CITY OF PORTLAND, MAINE
DEPARTMENT OF BUILDING INSPECTION

Memorandum from Department of Building Inspection, Portland, Maine AP - 1851 Washington Avenue

been staked out in the ground for checking by this department, a clack of the plans filled with the application for a purmit for construction of a single family dwelling, breezeway, and two car garage at 1847 fashington Avenue raises a number of questions about which may information is needed. These are as follows:

AP 1847 Washington Ave.

JOCINDATION PLAN - AND PLOT PLAN

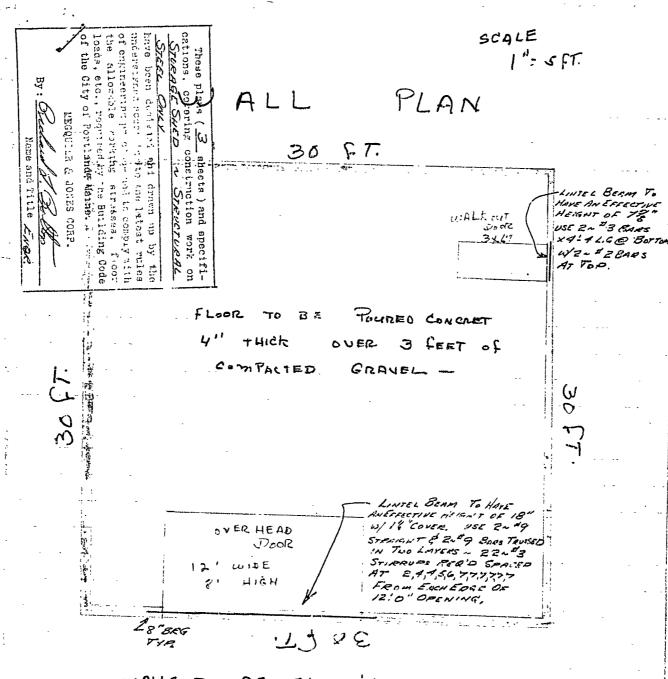
GOOTINGS TO DE 1 FT. DEEP. 16" WIDE DELOUP FROST LEVEL. AT LEAST 4 FT. BELLOW-

WALLS TO BE 8" THICK - 9 FT HIGH

LINTALS OVER DOORS TO BE BURED

CONCRETE REINFORCED WITH STEEL STRAN BARS-
